472
भारत सरकार-रेल मंत्रालय
अनुसंधान अभिकल्प और मानक संगठन
लखनऊ- 226011
Government of India - Ministry of Railways
Research, Designs & Standards
Organization, LUCKNOW - 226011

Modification Sheet No: RDSO/2012/EL/MS/0409(Rev'0')

Provision of N/O interlock of QCON relay in the circuit of QTD 101 coil to avoid SI unit tripping due to working of compressor in soft start mode in rear loco of multiple unit.

Modified Circuit

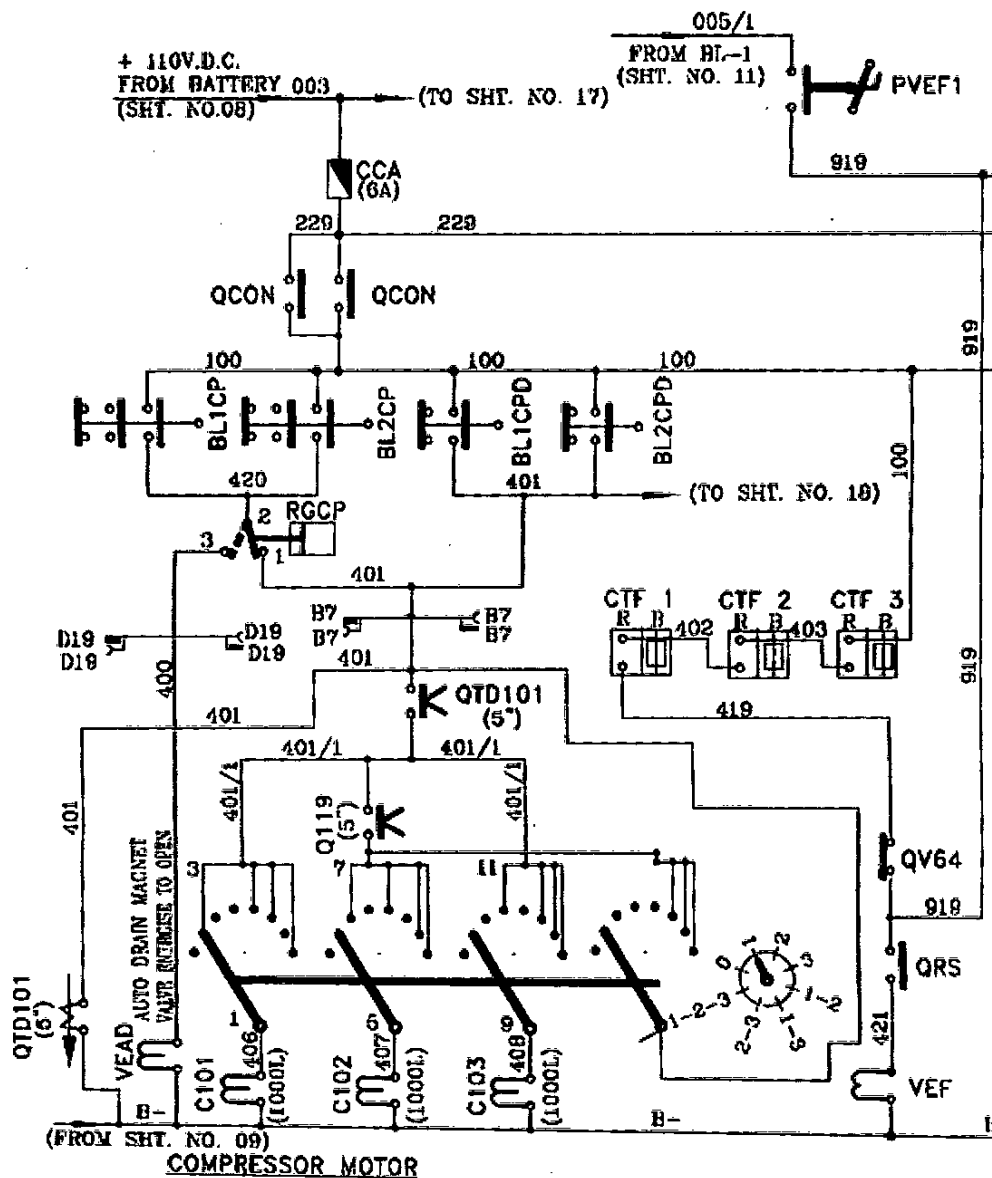
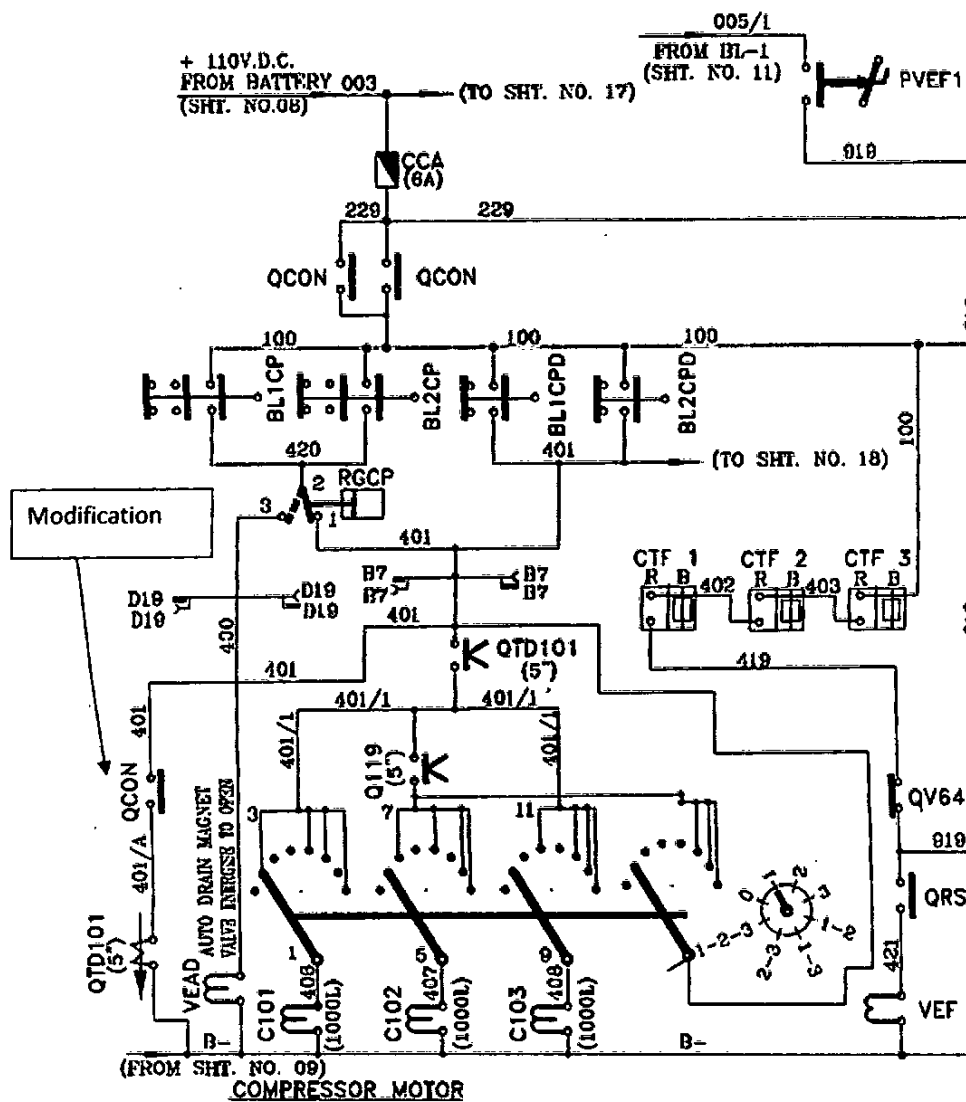
Though RDSO specification of SI unit stipulates that SI unit should be able to reach to its rated output voltage in 15 second but differences in ramp up time of different make SI units have been observed. During MU operation, if ramp up time of SI unit of lead loco is less than that of rear loco, then QCON relay of leading loco picks up early thereby indicating to driver to switch ON compressor. When BLCP is put to "ON", compressor contactor of both locos pick up. As SI unit of rear loco is yet to ramp up to its full voltage, overloading by compressor takes place, resulting SI unit tripping in rear loco.

As there may be minor differences in ramp up time of different make SI units, it is proposed to provide N/O interlock of QCON relay in the circuit of QTD 101 coil to avoid the problem of tripping of SI unit in rear loco while working in MU. With this

Take out wire No: 401 from QTD101 coil and connect it to spare N/O terminal of QCON relay. Connect other end of N/O interlock of QCON to QTD 101. Existing & modified circuit schematic and cabling index are attached as Annexure-I, II & III.

modification, even if compressor "ON" command is available from lead loco, rear loco Compressor contactor shall not close until its SI unit has fully ramped up. Draft modification sheet was circulated to railways vide RDSO letter of even no: dated 28/02/2012 for comments CR,NR,NCR,SCR,WR and WCR has commented acceptability of modification.
